Project
Proposed Alterations & Extension to
Roman Lodge
Tydd St. Mary
Spalding
Lincolnshire PE13 5SB

Title
Proposed Elevations

Drawing No.
B2043/09

NORTH-EAST ELEVATION

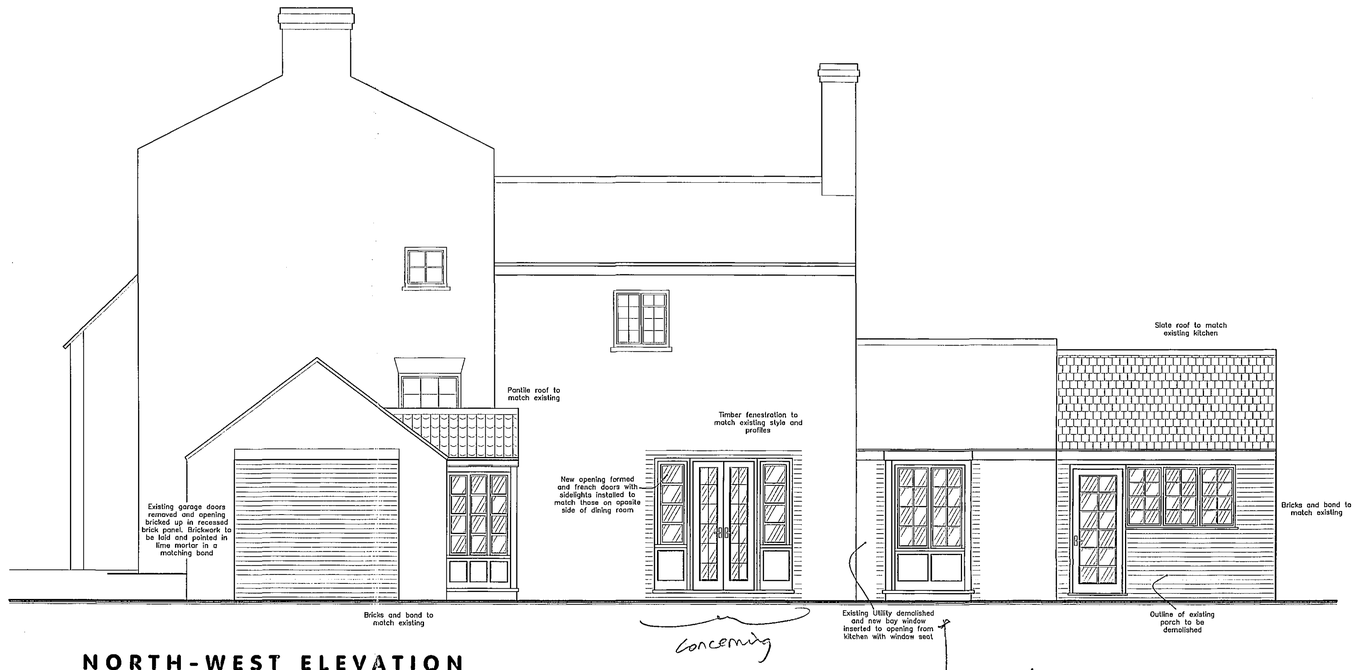
Creates unwelcome symetry in assymetrical building. Inappropriate.

concerning

Inappropriate to draw inspiration from modern bay window on opposite side
